MONTGOMERY COUNTY HISTORIC PRESERVATION COMMISSION
STAFF REPORT

Address:	707 New York Avenue, Takoma Park	Meeting Date:	4/22/2026
Resource:	Non-Contributing Resource Takoma Park Historic District	Report Date:	4/15//2026
Applicant:	Mark Hishmeh, Ace Construction LLC (Ben Norkin, Architect)	Public Notice:	4/82026
Review:	HAWP	Tax Credit:	No
Permit No.:	1143852	Staff:	Laura DiPasquale
Proposal:	Demolition of existing house, tree removal, hardscape alterations, and construction of new single-family house

Staff recommends the HPC **approve with four (4) conditions** the HAWP application, with final approval authority delegated to staff:

Figure 5: The previously-proposed conceptual site plan and massing rendering reviewed at the January 7, 2026 HPC meeting.

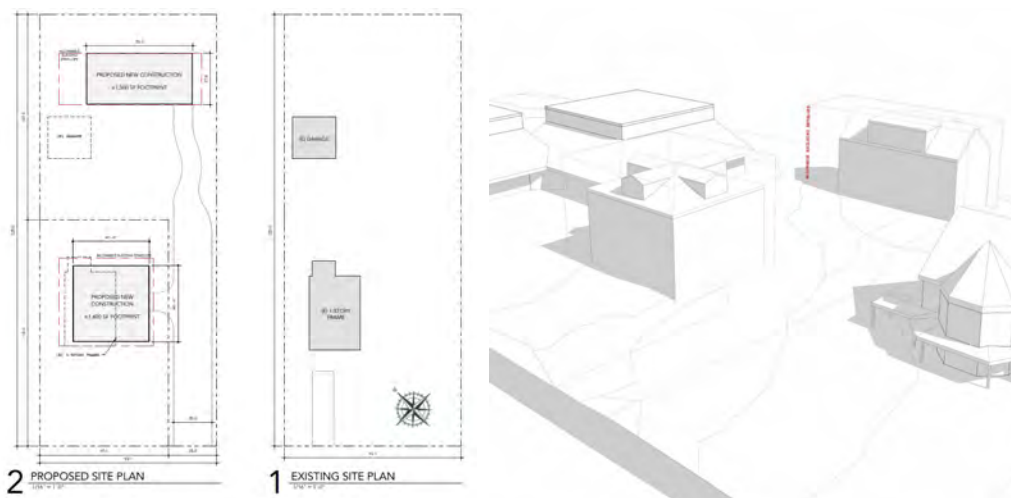
The HPC held a preliminary consultation review for the subject property at its January 7, 2026 meeting. At that time, the applicants proposed to subdivide the existing parcel into two lots (the front lot being approximately 8,000 sq.ft. and the rear lot being approximately 12,725 sq.ft.), demolish the existing Non-Contributing house and garage, and construct two single-family houses on the subdivided lots, accessed by a shared 20-foot wide driveway. Three large canopy trees were proposed for removal to accommodate the new construction. At that meeting, HPC generally concurred with the staff findings and recommended a comprehensive reconsideration of the proposal.

Figure 6: Front elevation of the proposed house from the March 11, 2026 preliminary consultation (left) and revised (right).

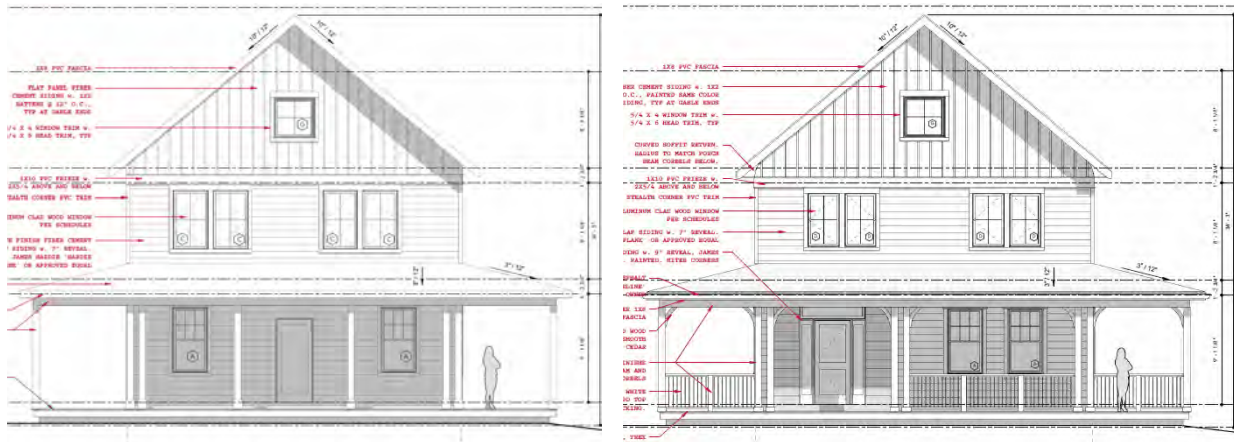
Staff finds that the revisions included in the current proposal address many of the HPC's comments from the March 2026 preliminary consultation review. In the revised application, the applicants have maintained the overall form of the proposed construction, but have slightly reduced and broken up the massing by pulling the back rooms in between 18 inches and 2 feet from the rear and 16 inches in from the side to create the appearance of a rear addition. The applicants have also reduced the size of the dormers and pulled them back 2-feet 10-inches from the front elevation. At the first floor, the applicants have also addressed comments about the fenestration, revising the first floor to shift the entry to the left and enhancing the opening with a projecting entrance bay including an entry door flanked by sidelights and topped with a transom. Additional fenestration was also added to the northwest side elevation of the front of the house. The applicants reduced the height of the upper floor fenestration slightly, but maintained the 6-over-1 double-hung first floor windows and 4-light casement window configuration on the upper floors. The applicants addressed comments about the porch column pattern and thickness, increasing the thickness of the proposed columns and adding a railing, which further highlights the proposed front entry.

For the cladding of the proposed house, the applicants propose a combination of smooth-finish 7-inch reveal James Hardie fiber cement lap siding, smooth-finish 9-inch reveal James Hardie fiber cement shiplap siding, and flat panel fiber cement siding with 1x2 battens. For the windows, the applicants propose Pella Reserve aluminum-clad windows with 7/8-inch ogee simulated-divided-light grilles. For the exterior trim, the applicants propose Azek Classic white trim. Roofing would be GAF Timberline HDZ architectural shingles. Staff finds that all of these materials are compatible for use on the proposed house, per *Standard 9* and Chapter 24A-8(b)(2).

Figure 12: Height comparison of the proposed house at 707 New York Avenue and the neighboring Outstanding resource at 703 New York Avenue.

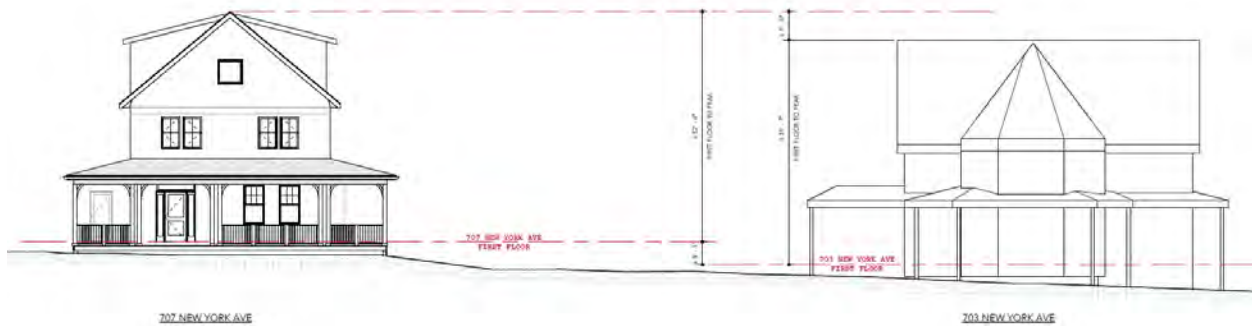
At the March 2026 preliminary consultation review, the HPC also requested additional information on the height of the adjacent historic building at 703 New York Avenue. The applicants have provided additional information showing that the roof peak of the neighboring house will be approximately 4 feet lower than that of the proposed house. While the HPC found that the proposed roof height should not exceed that of the adjacent historic resource, staff notes that approximately 3-feet 3-inches of the height difference is owing to grade change, making the two buildings approximately the same height, discounting grade. While staff would typically find 34 to 35-ft in height for new construction overly tall for a smaller interior lot in the district, given the large size of the proposed lot and its location at the along two of the district boundary lines, the position of the proposed house approximately 70 feet from the adjacent Outstanding resource, and the setback of the proposed house over 50 feet from the public right-of-way, staff finds that the overall height is compatible with the district in this location and will not seriously impair the district or adjacent historic resource, per Chapter 24A-(d).

Figure 14: Detail of the proposed site plan showing the proposed gravel driveway extension and concrete paver walkway.

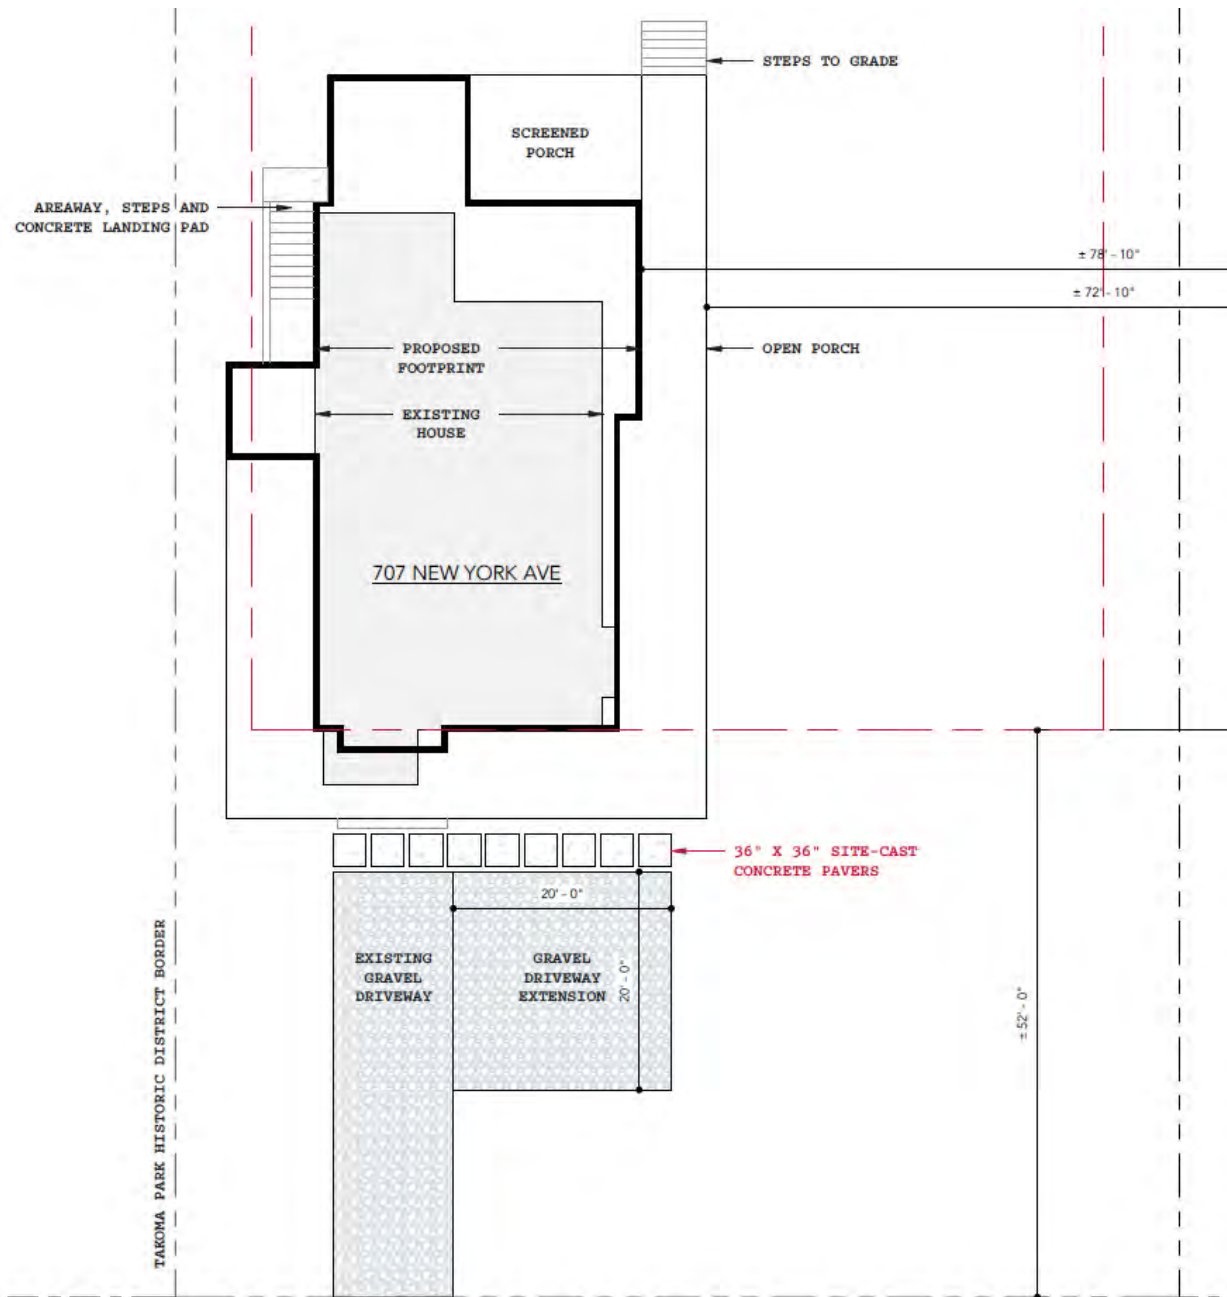
New to the current proposal is the addition of a 20-foot by 20-foot gravel driveway extension and paver walkway in front of the house. While staff would typically discourage the installation of parking in front of the house, staff finds that, based on the site restrictions and existing curb cut, as well as the driveway discussion at the first preliminary consultation review, the proposed parking is acceptable provided it will not damage the existing adjacent 22.5-inch Northern Red Oak or 19.5-inch d.b.h. Maple trees (see *Figure 15*). Staff recommends that the applicants submit a tree protection plan and Takoma Park arborist's assessment demonstrating that the proposed work will not irreparably damage any existing trees.

Figure 15: The proposed tree removal and replanting plan. Red circle overlays show the critical root zones of the existing trees adjacent to the driveway and proposed driveway extension, based on the March 2026 preliminary consultation review tree survey

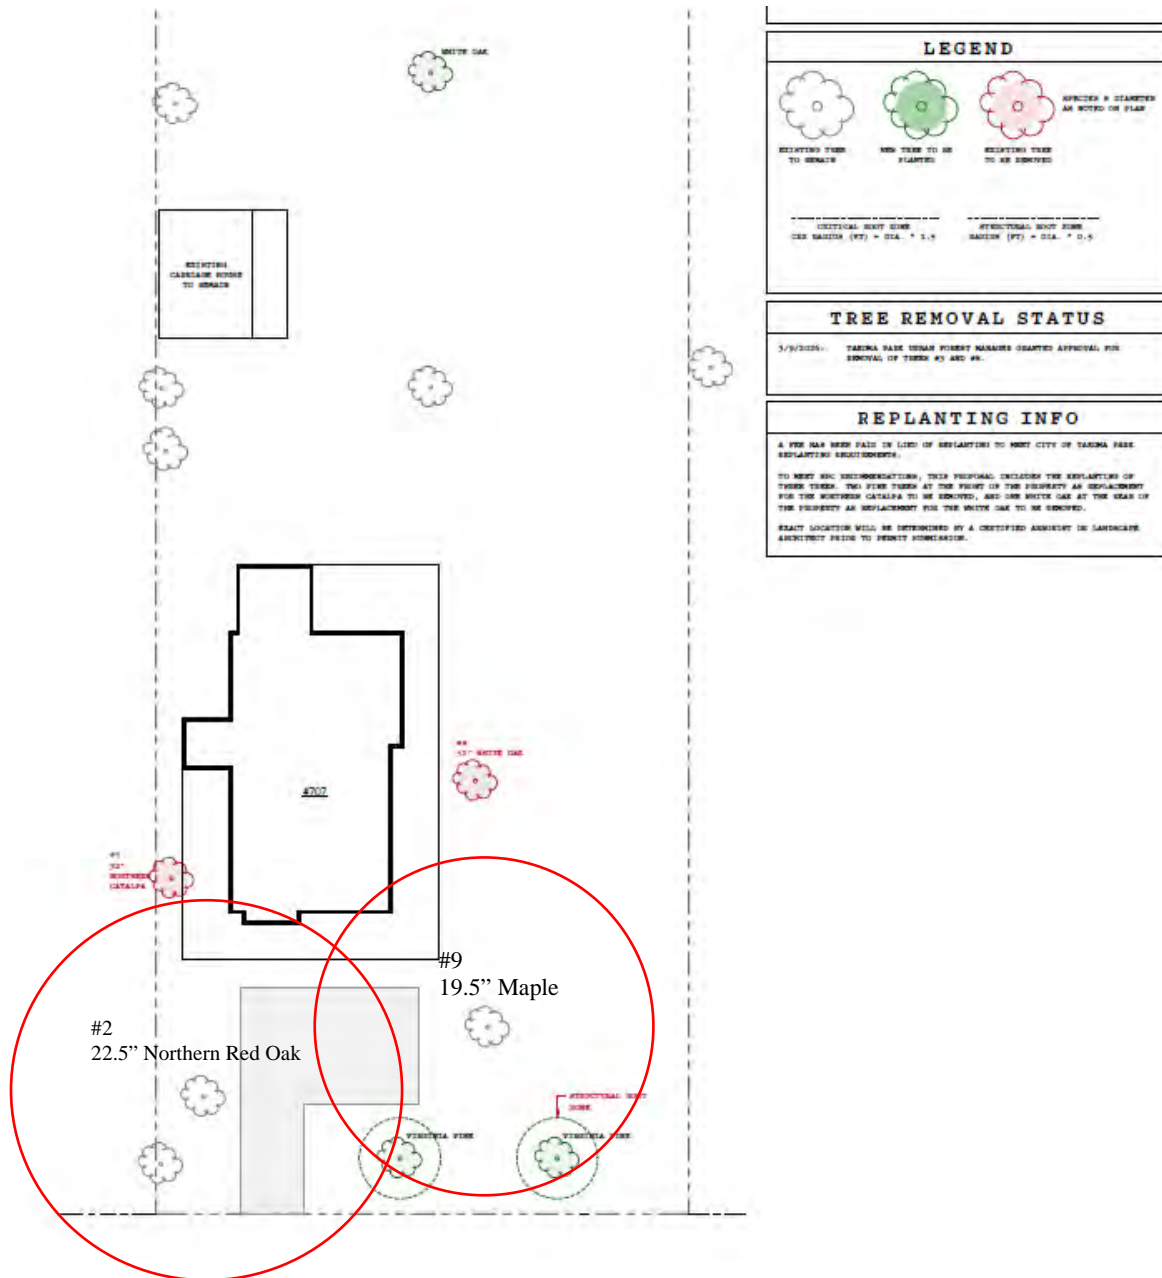
To accommodate the new construction, the applicants propose to remove two existing mature trees, a 32-inch dbh Northern Catalpa and a 31-inch dbh White Oak. At the March 2026 HPC meeting, the HPC agreed to the removal of these two trees, provided new canopy trees were planted on site, as the district’s tree canopy is important to its significance, per the *Guidelines*. The applicants have included a replanting plan in their current proposal calling for the planting of one White Oak (a large species canopy tree) in the rear yard and two Virginia Pine trees (medium size trees) in the front yard, near the street. Staff finds that the placement of two medium-size trees along the front property line makes sense given the overhead power lines, but finds that these trees will not contribute significantly to the overall district tree canopy and recommends that one to two additional large-species trees be planted in the side yard.

1. The proposed Trex Classic porch railing with charcoal balusters is not approved. The applicant must submit a more compatible railing specification with a single, paintable material with balusters installed between the top and bottom rails.
2. The applicant must submit a tree protection plan and implement any recommendations from the Takoma Park arborist to prevent irreparable damage to any existing trees for the installation of the proposed hardscaping.
3. The proposed gravel driveway must be fully permeable.
4. The applicant must plant one to two large species canopy trees in the southeast side yard of the property.
